**MAINE TURNPIKE AUTHORITY**

**ADDENDUM NO. 1**

**CONTRACT 2016.05**

**BRIDGE REPAIRS**

SHEET NUMBER: MOT-07

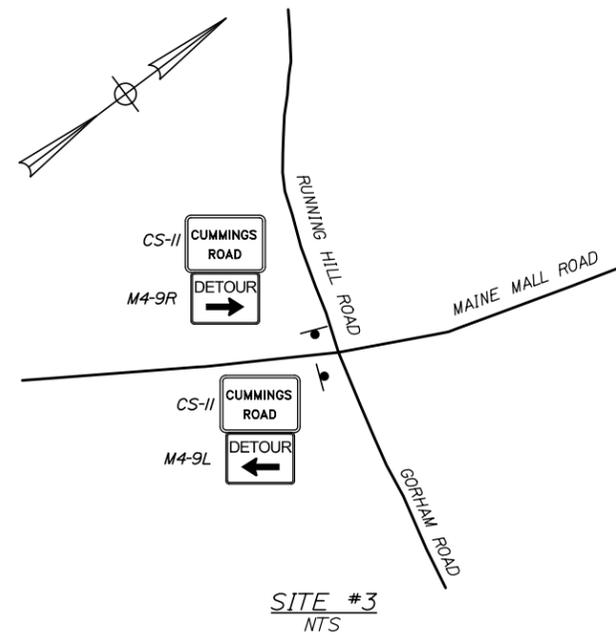
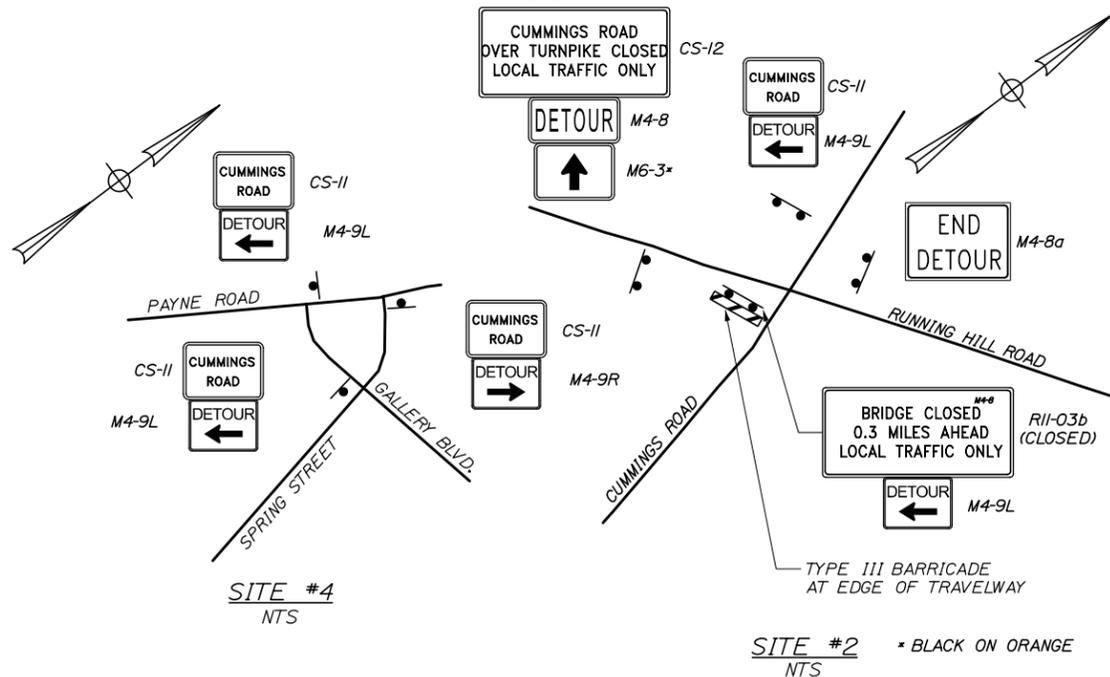
Sheet MOT-07 sheet 9 of 35 is revised as follows: Detour Plan and associated traffic control has been added.

No.	Revision	By	Date
1	Addendum #1 - Detour Added	AES	04/16

CUMMINGS ROAD TRAFFIC CONTROL SHALL CONSIST OF A DETOUR ROUTING THE TRAFFIC OVER THE BRIDGE TO THE EAST ACROSS PAYNE ROAD, MAINE MALL ROAD AND RUNNING HILL ROAD. TEMPORARY LOCAL ROAD TRAFFIC STOPPAGES ARE NOT ANTICIPATED.

**GRANITE CURB REPAIR DETAIL**  
N.T.S.

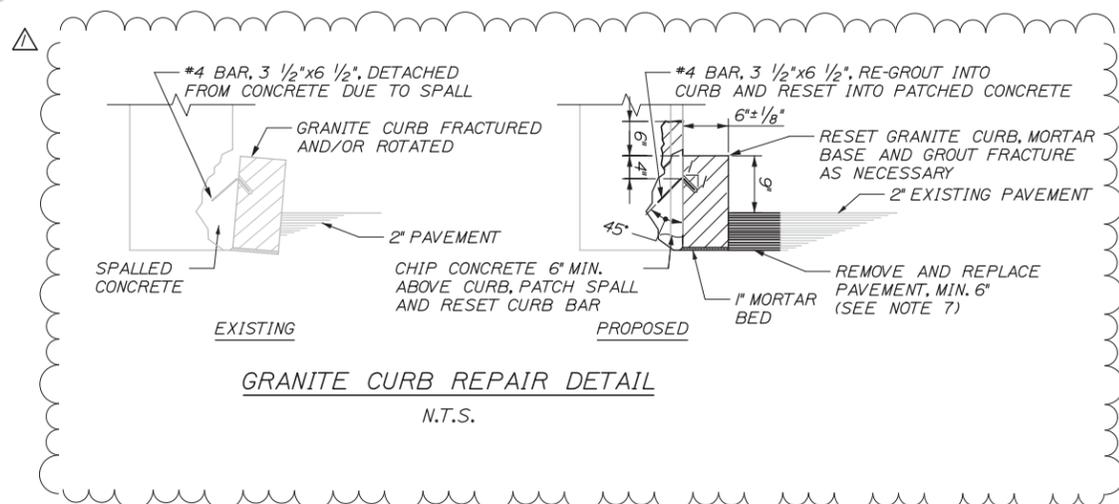
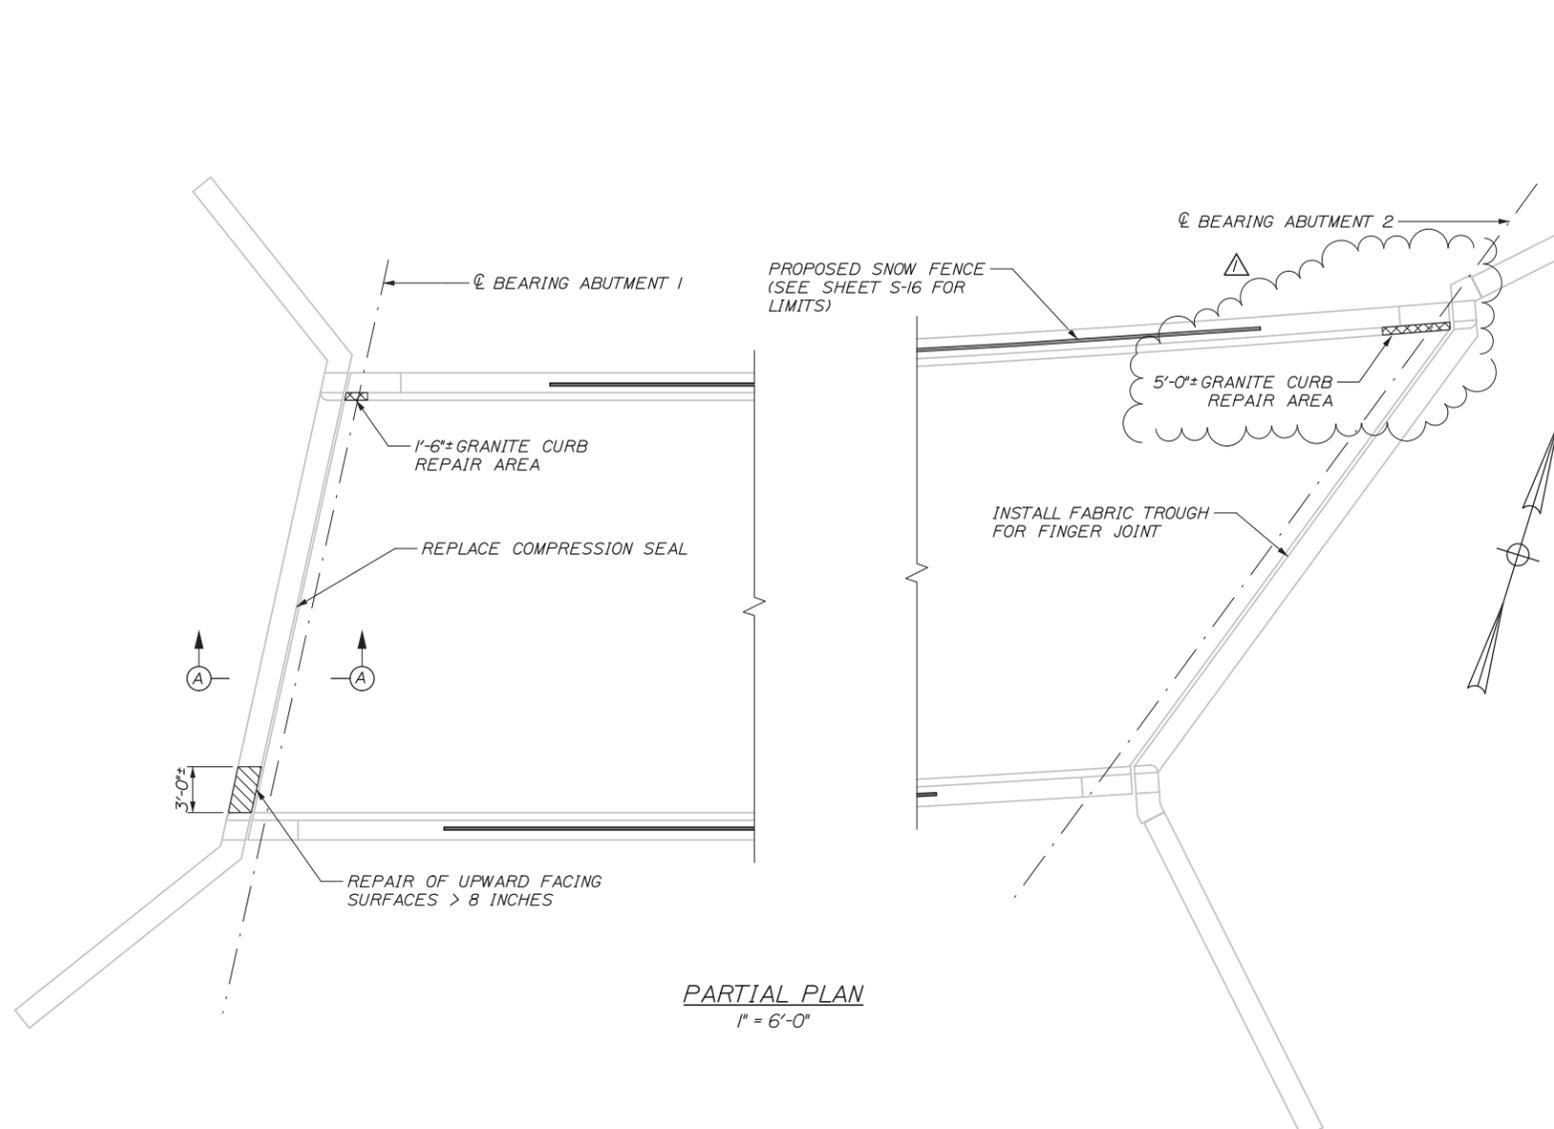
Sheet S-01 sheet 16 of 35 is revised as follows: Granite curb repair detail and note has been added. Concrete header note 6 has been updated.

Answer: The intent of the granite curb repair on Ramp J is to remove and reset the damaged portion of curb at the locations noted on the plans. An additional detail has been provided on Sheet S-01 to clarify the detail.

No.	Revision	By	Date
1	Addendum #1 - Added Repair Detail	AES	04/16

- THE CONTRACTOR SHALL REMOVE THE PAVEMENT AND MEMBRANE ADJACENT TO THE GRANITE CURB REPAIR AREA TO EXPOSE THE MORTAR BEDDING. THE CURB SECTION SHALL BE REMOVED AND RESET IN ACCORDANCE WITH THE REPAIR DETAIL. SOPREMA ASLAN FLASHING RUBBERIZED SEALANT OR APPROVED EQUAL SHALL BE APPLIED TO DECK ADJACENT TO REPAIR AREA AND PERMA-PATCH PERMANENT PAVEMENT REPAIR MATERIAL WILL BE PLACED TO MATCH EXISTING PAVEMENT. GRANITE CURB REPAIR SHALL BE PAID FOR UNDER ITEM 518.392 GRANITE CURB REPAIR IN ACCORDANCE WITH SPECIAL PROVISION 518. RUBBERIZED SEALANT AND PAVEMENT PATCH MATERIAL SHALL BE INCIDENTAL TO REPAIR ITEM 518.392 GRANITE CURB REPAIR.

SHEET NUMBER: S-02  
CONTRACT: 2016.05  
17 OF 35

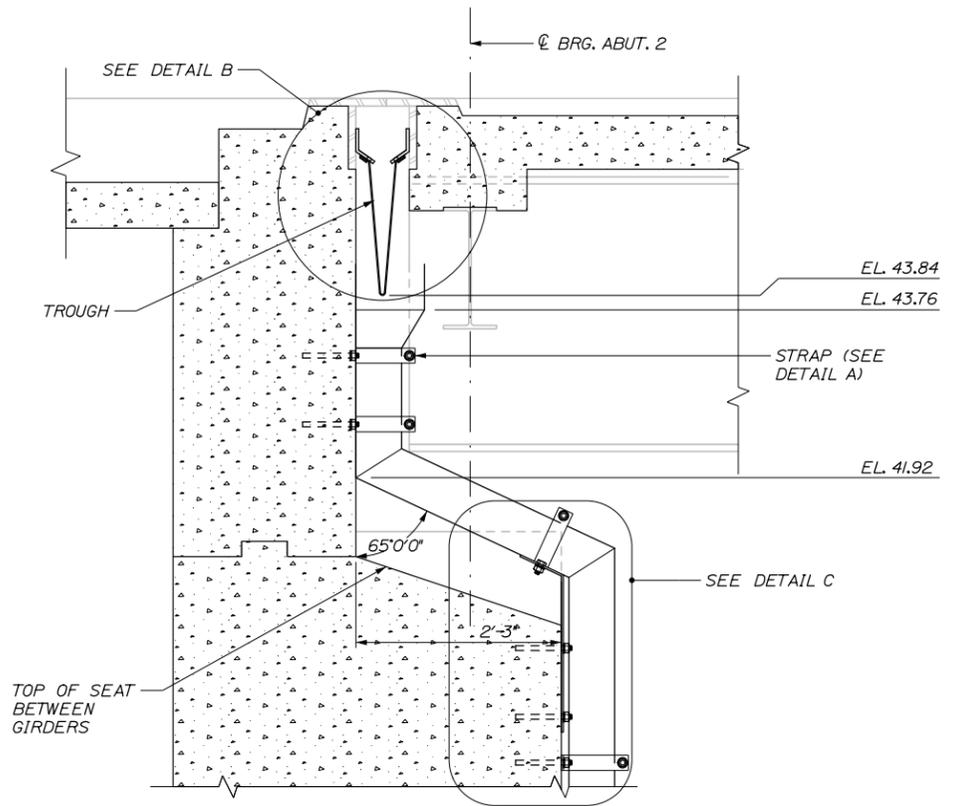
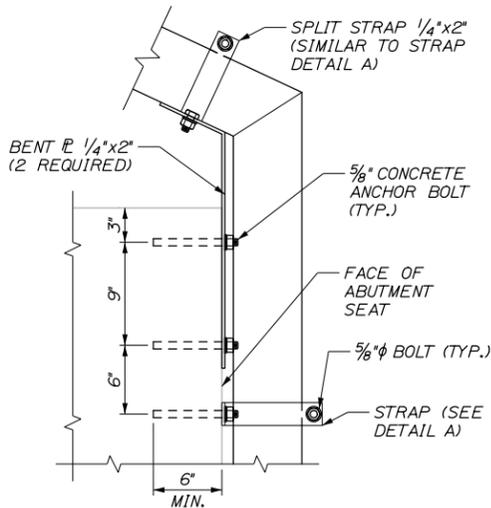
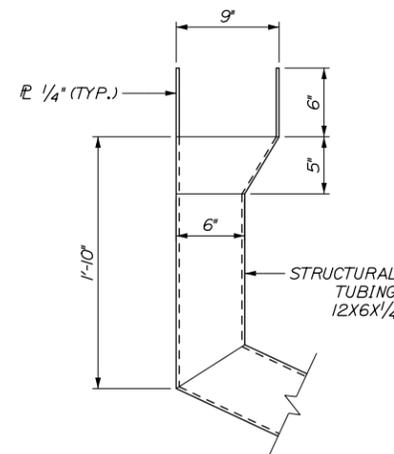
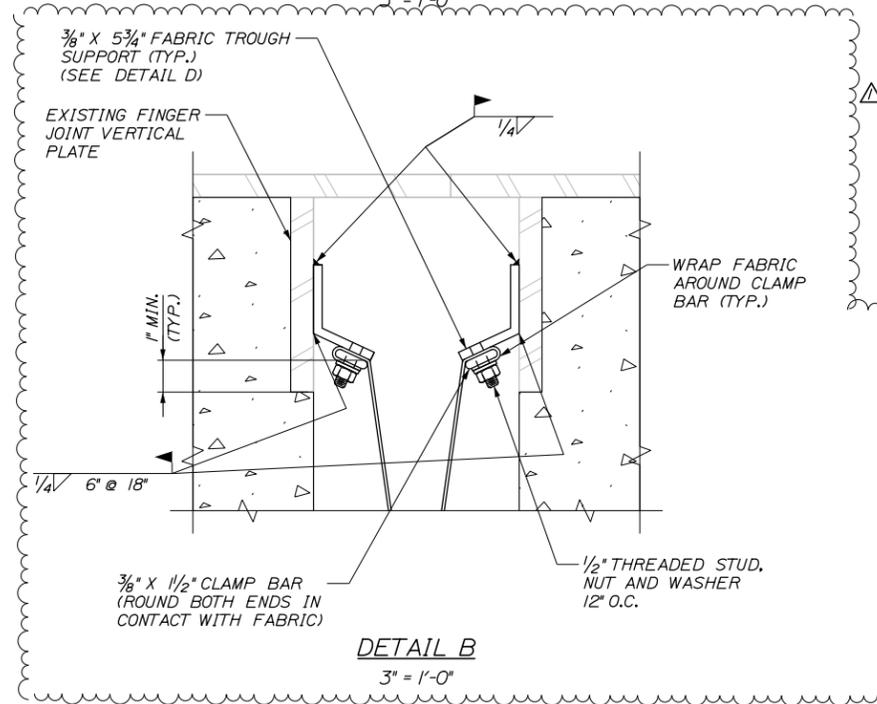
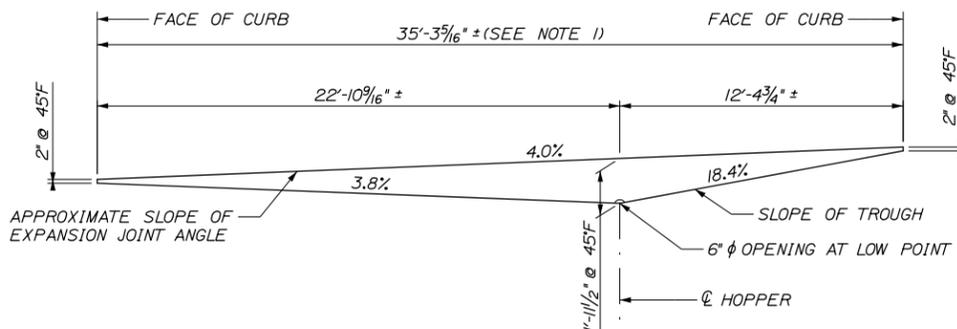
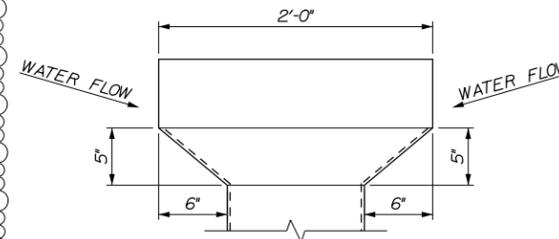
Sheet S-02 sheet 17 of 35 is revised as follows: Fabric Trough Support Detail has been modified.

Answer: Welding from the top side is accomplished through the finger joints, removal of the joint armor will not be permitted. The fabric is installed after the weld plates are installed. The fabric trough support geometry has been modified to allow for more access to the connections. See attached Sheet S-02.

SHEET NUMBER: S-05  
 20 OF 35

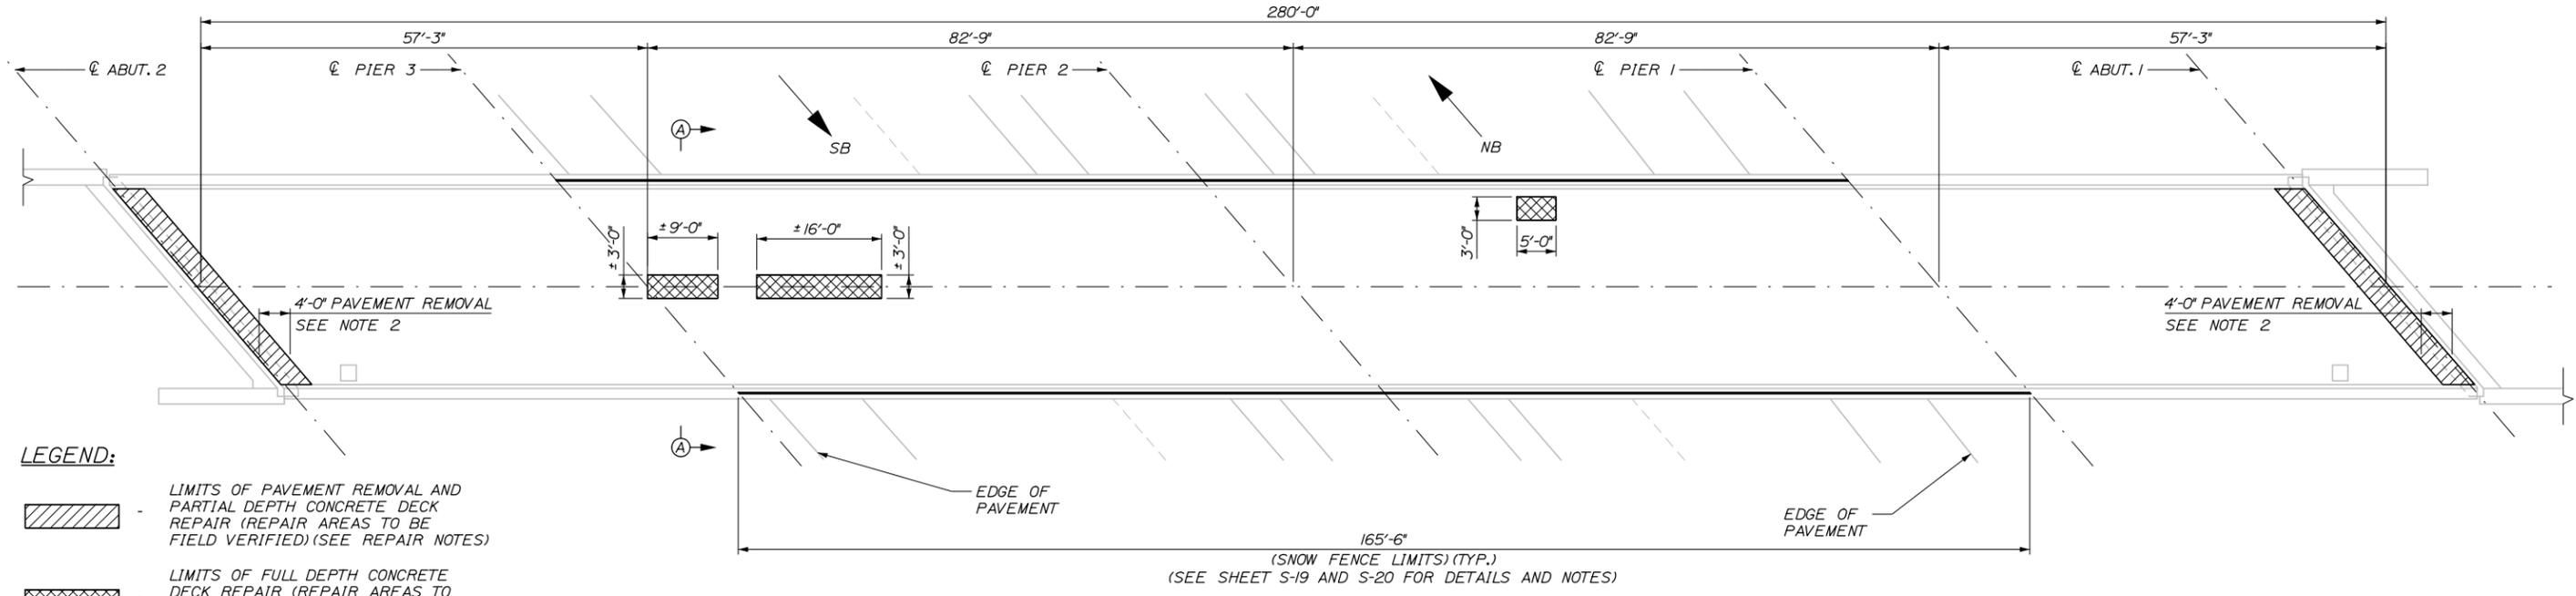
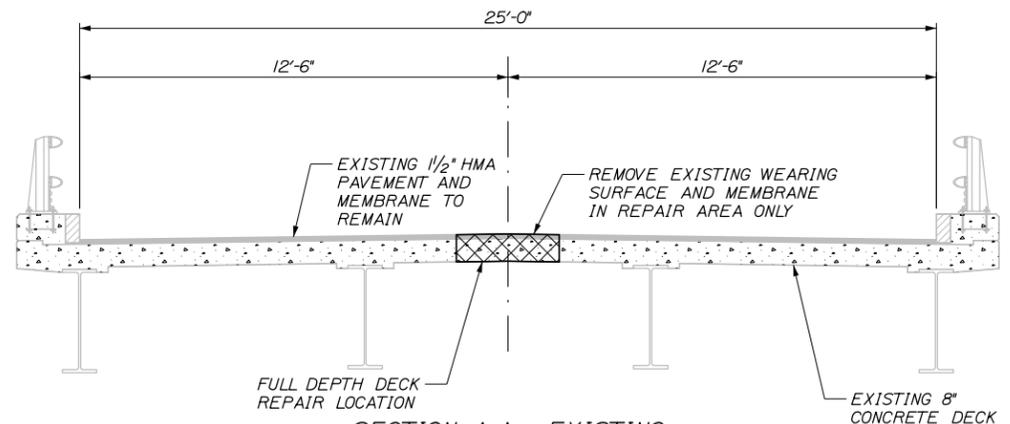
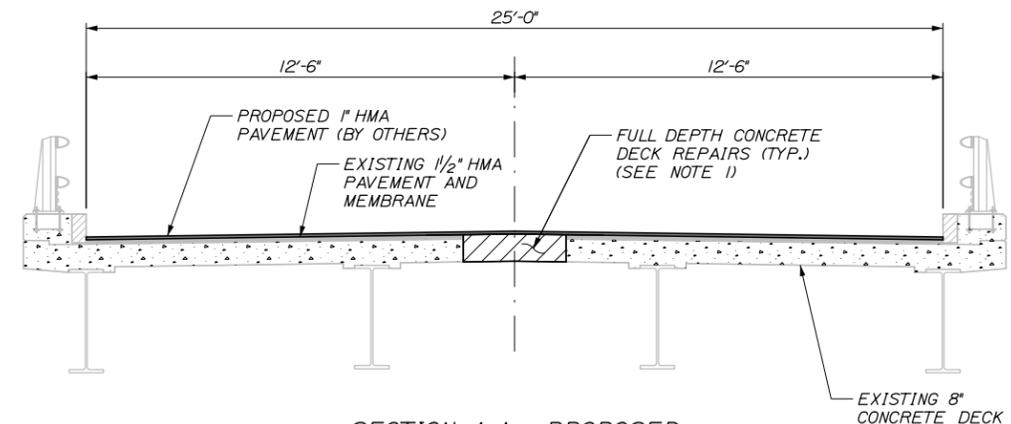
Sheet S-05 sheet 20 of 35 is revised as follows: Maintenance of traffic and work hour note 3 has been updated.
